18326 ROYAL OAK RD

PROPOSED PLOT PLAN

SOIL/SITE EVALUATION
for ON-SITE WASTEWATER SYSTEM

APPLICATION FOR IMPROVEMENT PERMIT FOR RESIDENTIAL SITE INDIVIDUAL WATER AND WASTEWATER SYSTEMS PROGRAM

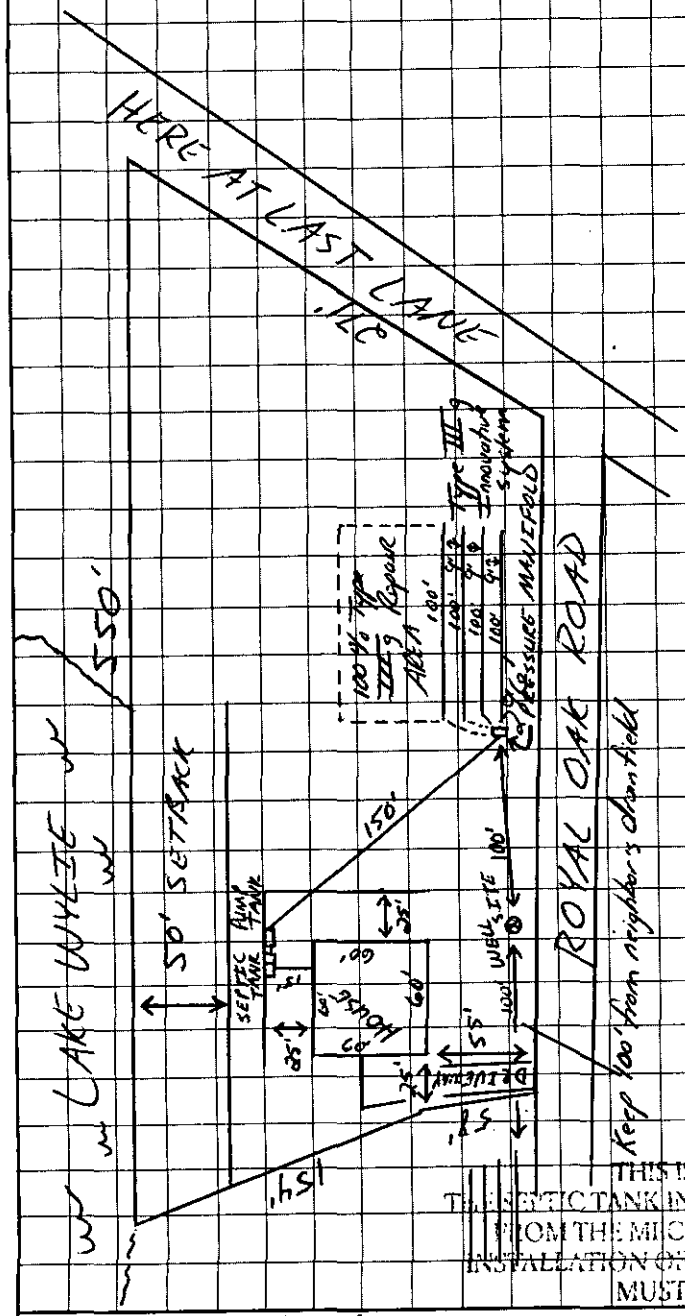
→ SCALE = 1" = 100'
→ Keep trenches level and on the contour of the land
→ Keep trenches shallow (36" Max.)
→ keep the minimum distances from the following:
- 25' from Basement foundation drain
- 10' from property lines
- 100' from ALL wells

→ System is designed for four (4) Bedroom house:
Type IIIb Innovative System

→ Install 4 lines x 100' (400 TLF)

→ Pressure Manifold shall be used.
